ADDENDUM NO. 2

FEBRUARY 28, 2024

Staunton City Public Schools, VA
Shelburne Middle School Additions and Renovations
CRA Project No. 3636

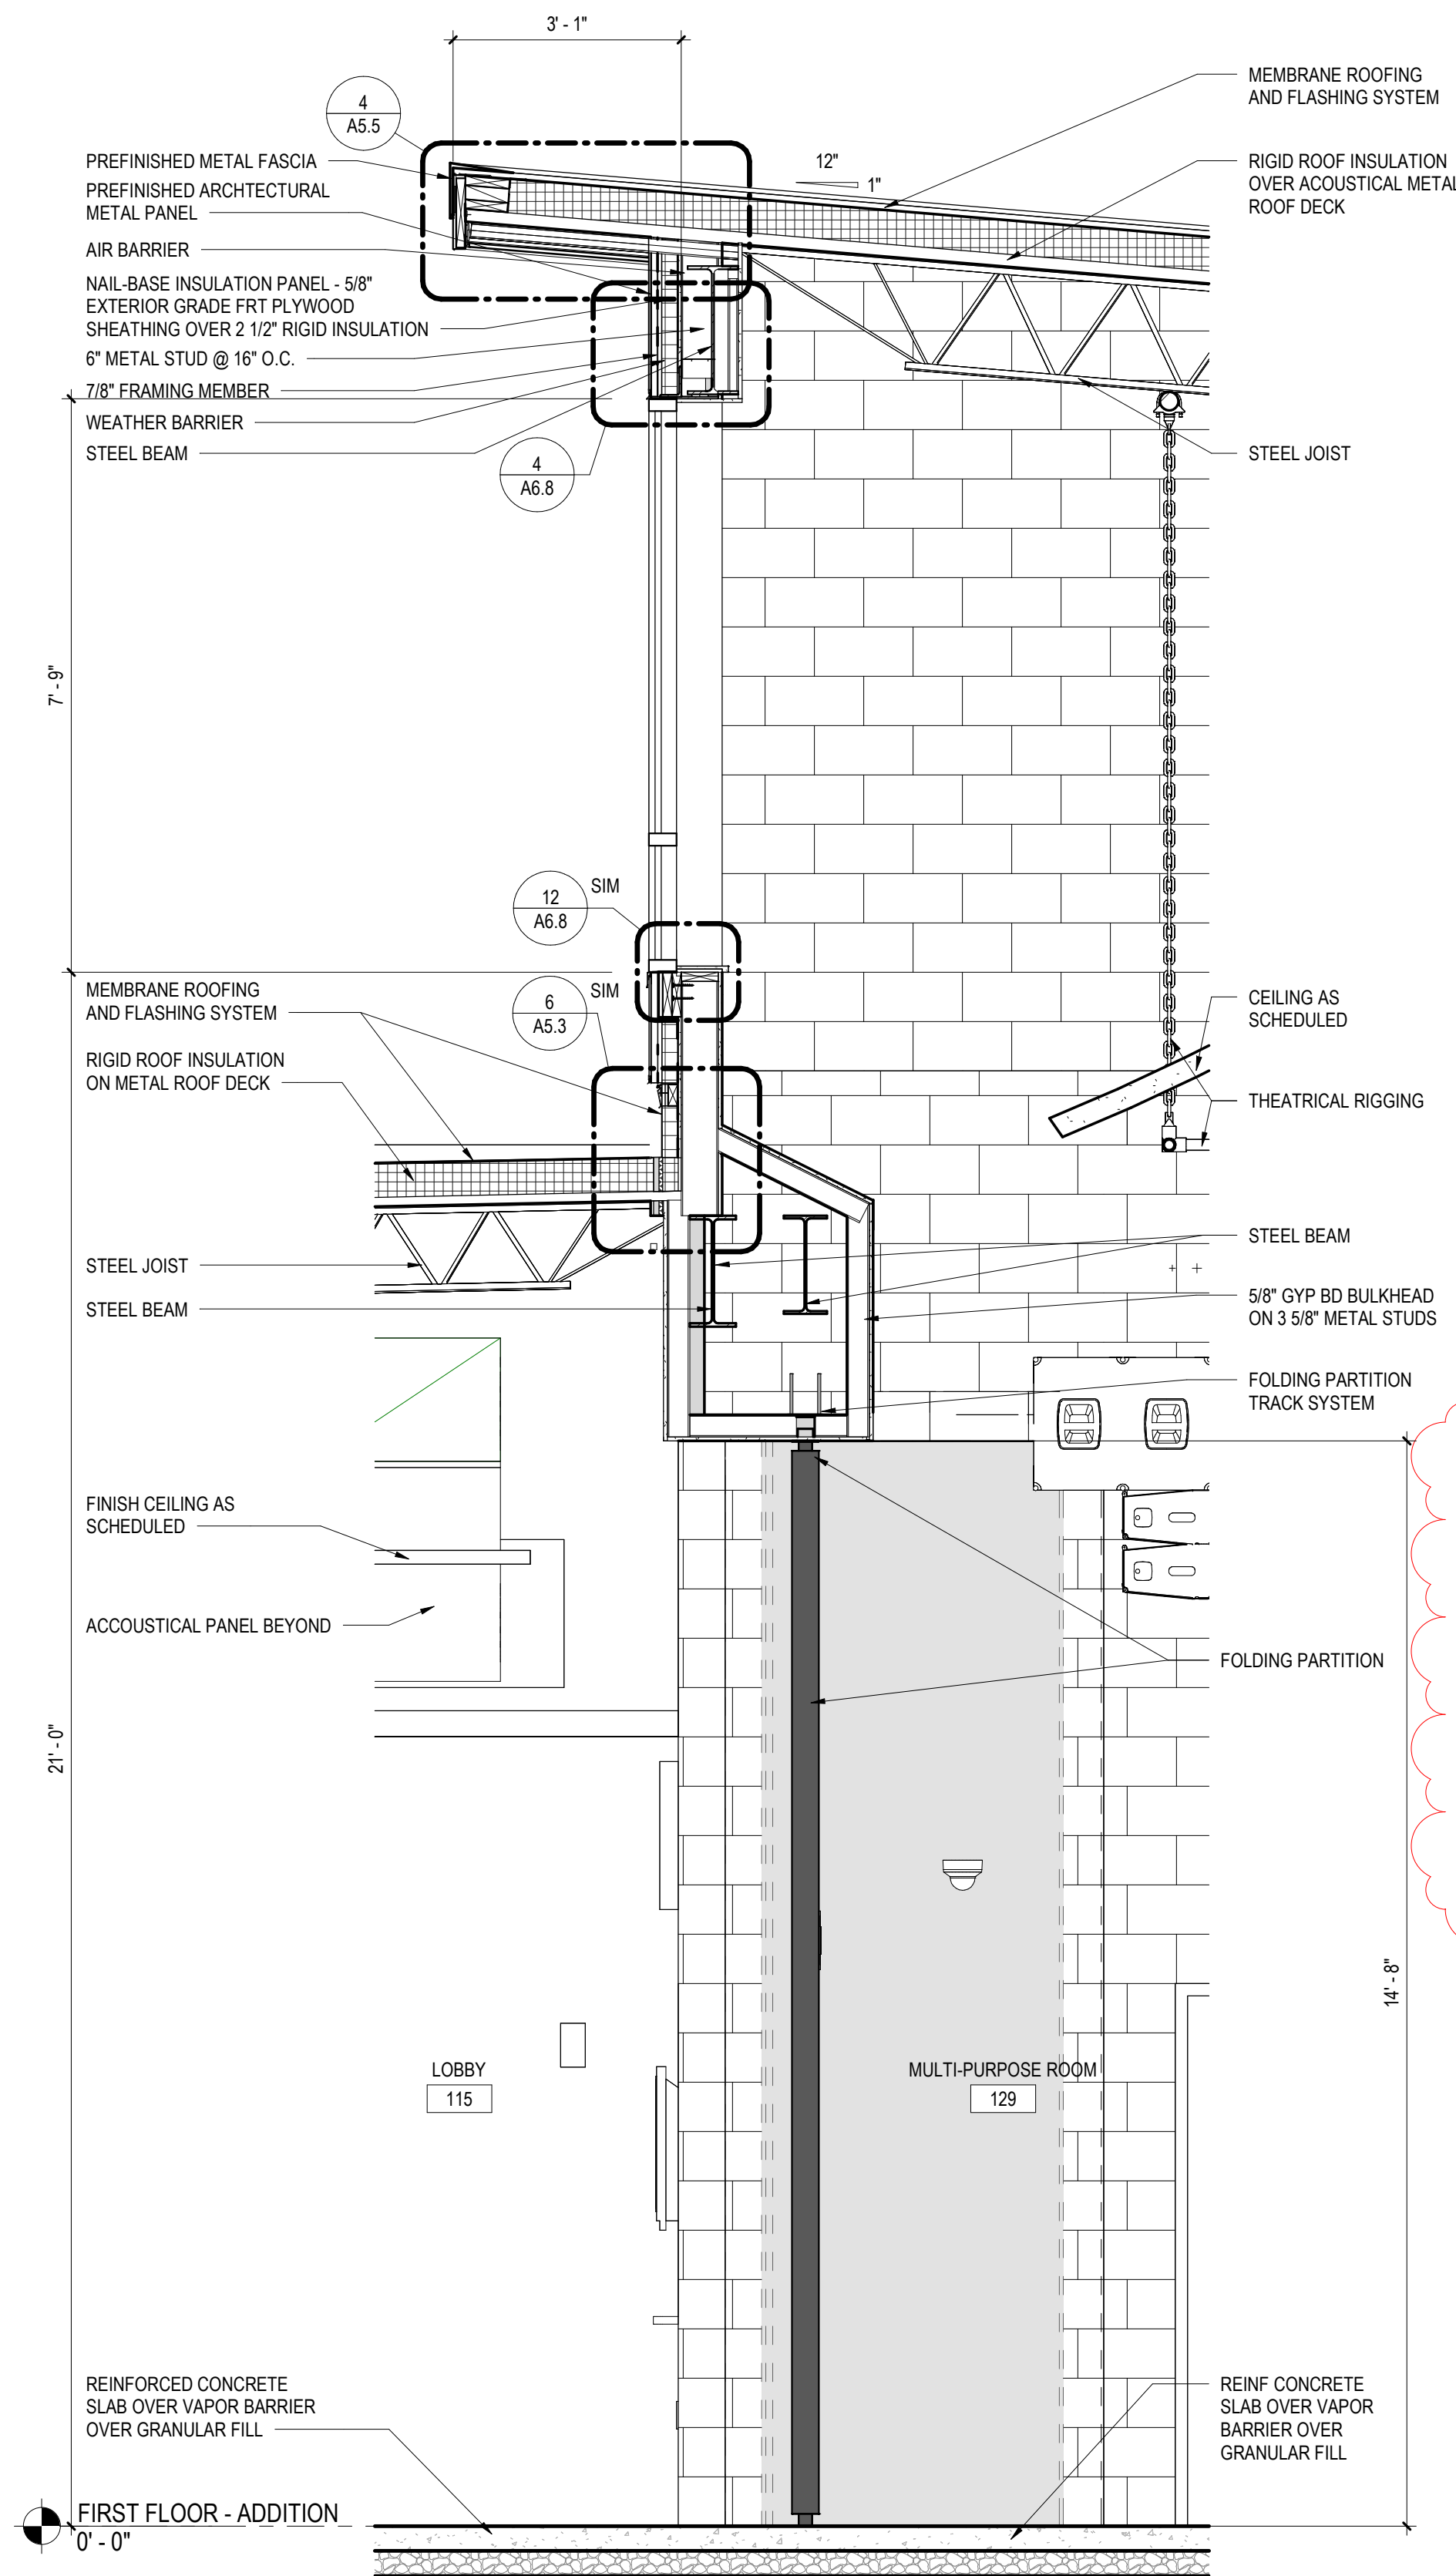
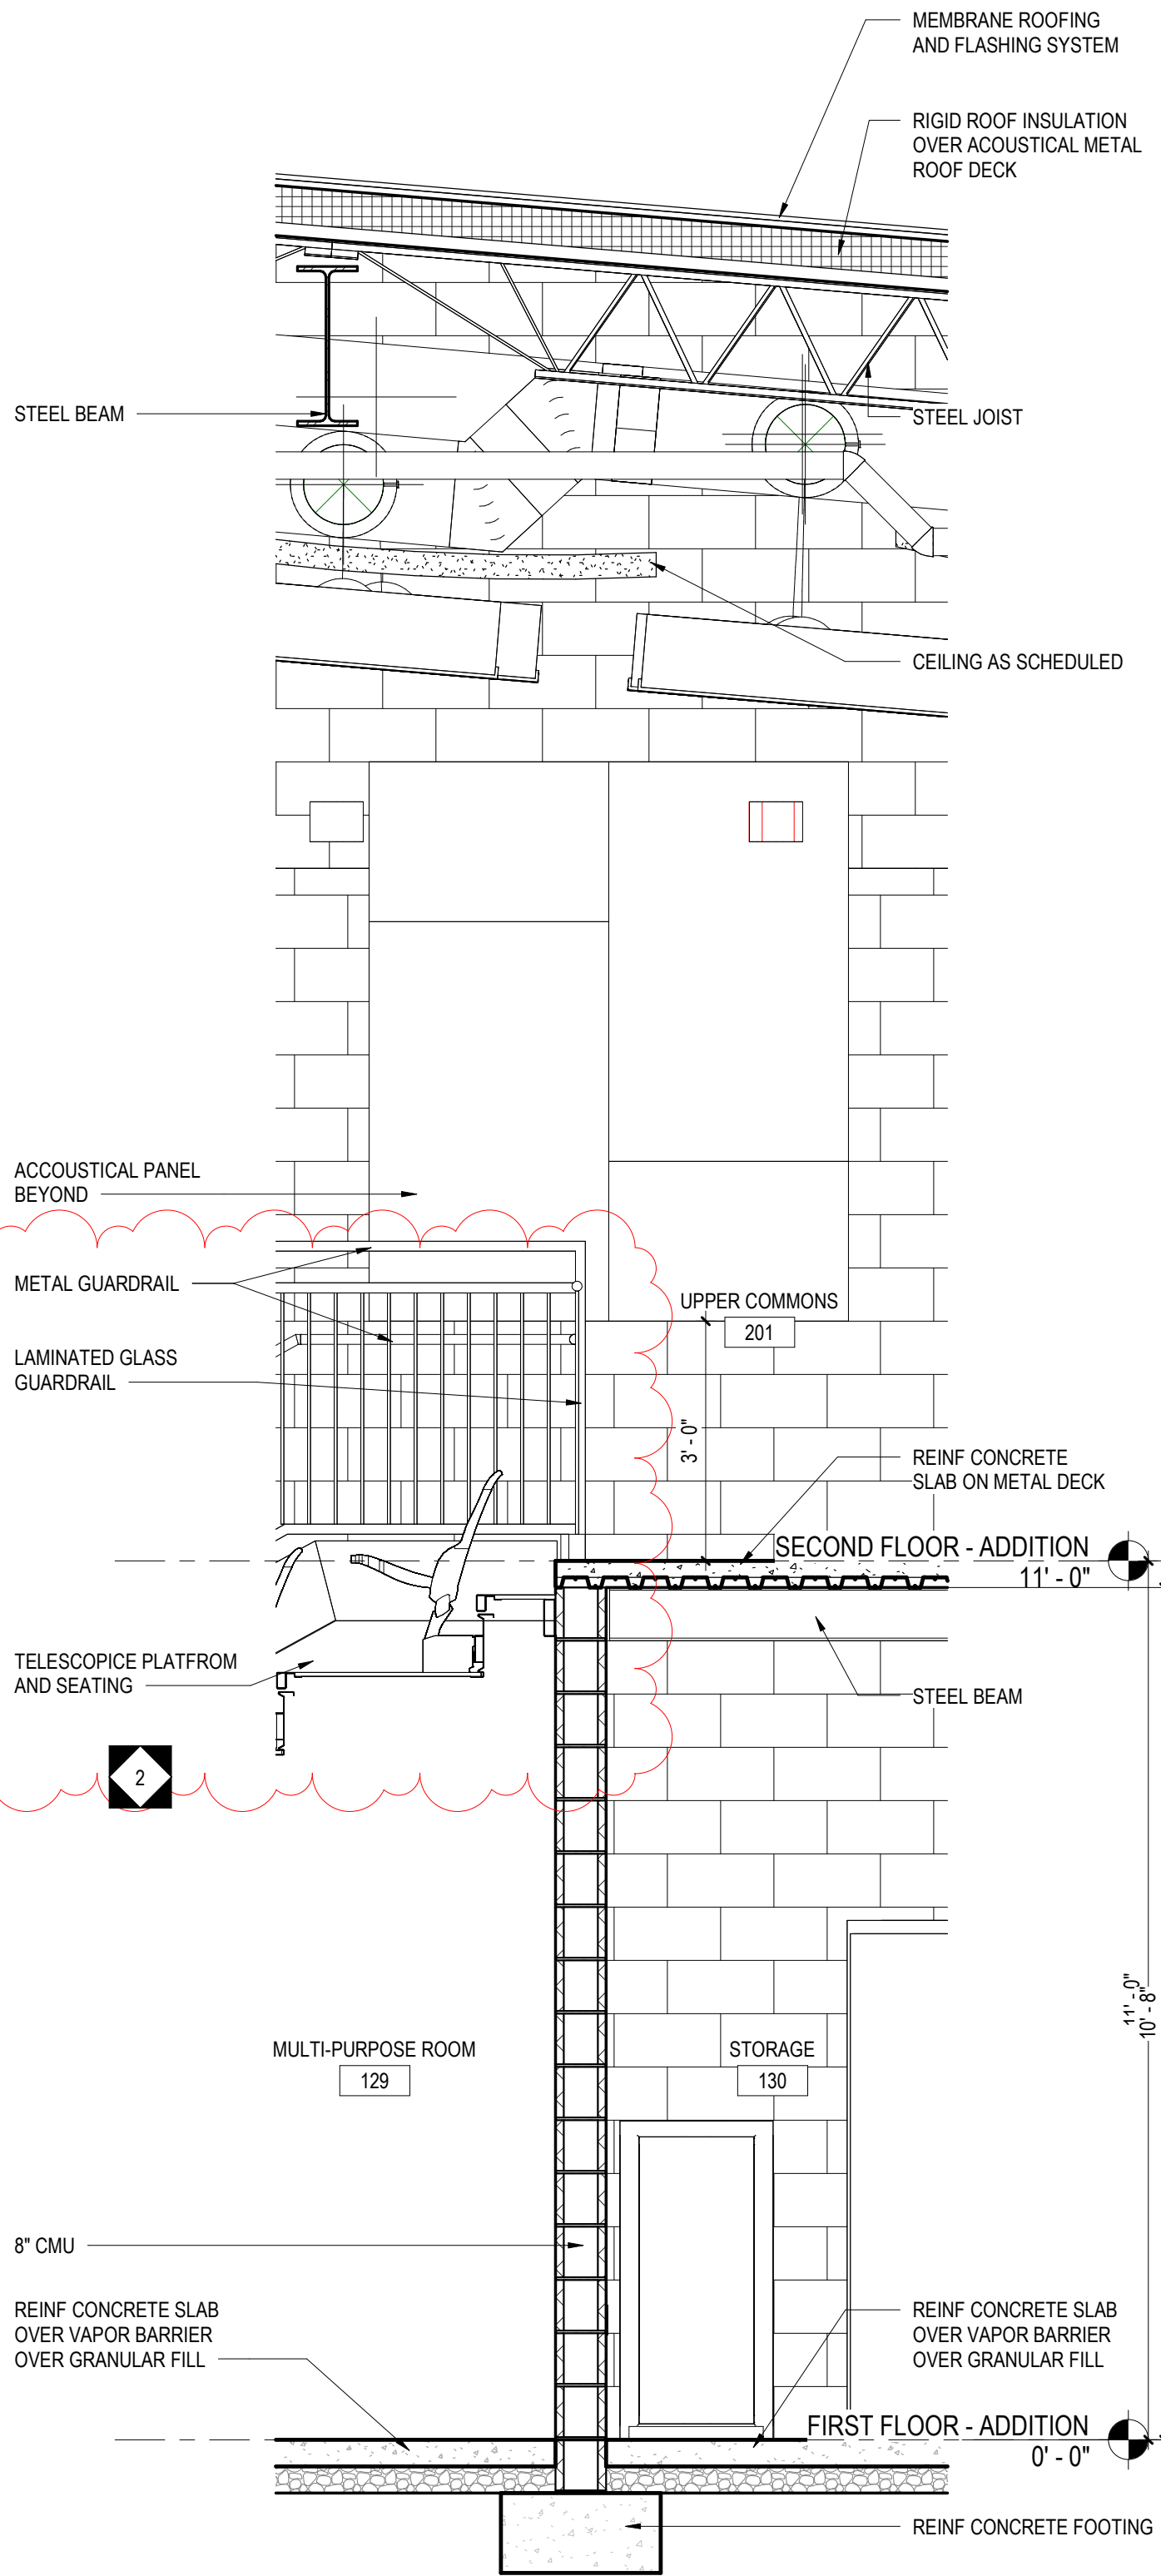
1. **DELETE** this sheet in its entirety and **REPLACE** with the attached sheet.

- a. **REVISED** notes identifying Telescopic Platform and Seating system.
